URGENT – FIELD SAFETY NOTICE
Concerto & Basic shower trolley

Date:	2019-AUG-16
Product Issue:	Concerto & Basic shower trolley – Potential unintentional drop of safety side panel
Affected Product:	<p>✓ Concerto & Basic shower trolleys manufactured between November 2018 and June 2019; [REDACTED]</p> <ul style="list-style-type: none"> Concerto & Basic shower trolleys fitted with the affected spare parts (safety catch) part no. 8451622, 8546608, S8533571-031, S8533572-031, S8533570-031 S8542201-014, S8523559-031, 100-805-03, 100-806-03 during service between 2018-Nov-27 and 2019-Jun-14
Affected Serial No.:	Attachment A
Resolution:	Safety catches replacement in order to ensure the device is operating safely
Field Safety Notice:	FSN-POZ-002-2019
Pages:	3 & Customer Response Form

Image 1

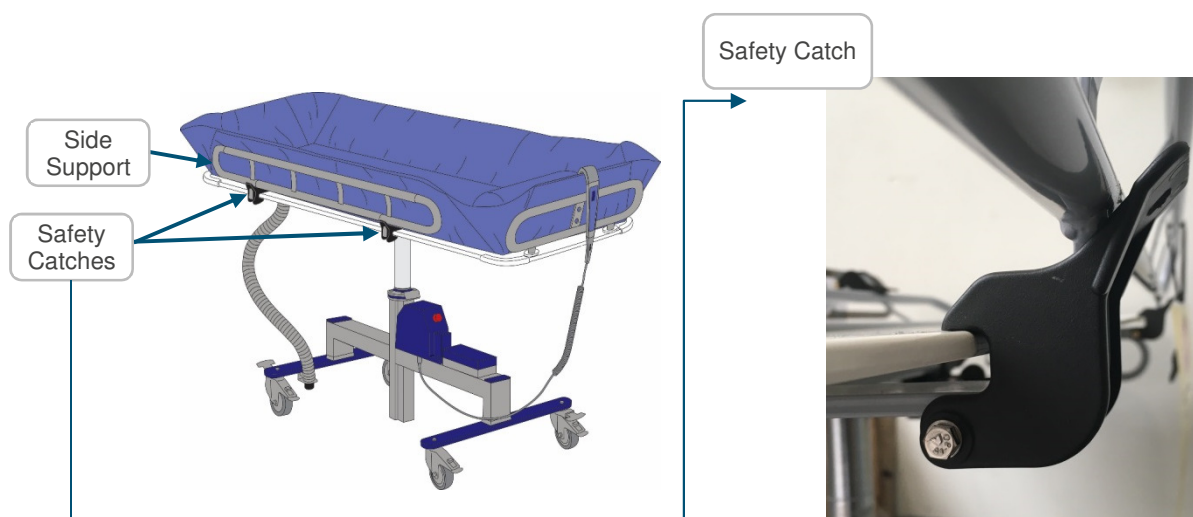
Each Concerto & Basic shower trolley is equipped with two Side Supports, one on each side of the shower trolley (Image 1). Each side support is secured by two (2) Safety Catches (Image 2) which are used to fold down the supports as well as secure the support in the raised position.

Arjo has become aware that any of the 4 Safety Catch(es) may exhibit a mechanical failure (break in one of the arms of Safety Catch), which in certain circumstances may contribute to the Side Support unintentionally opening and may lead to a potential risk of patient fall, leading to possible injuries to patient and/or caregiver.

1. Verify the condition of all 4 Safety Catches attached to your device. If you notice the break (as shown in Image 3) withdraw the trolley from use.

- ✓ It is recommended that the Safety Catches on the shower trolley Side Supports be inspected daily to ensure any of the catches are not broken as show on the Image 3.
- ✓ The patient is not left unattended at any time.
- ✓ The patient is fully assisted so that he/she does not grab, push or lean against the Side Supports during showering activities.
- ✓ Caregivers should limit pulling and pushing of the Side Supports with excessive force.
- ✓ **Note:** always adhere to the Safe Working Load as outlined in the IFU.
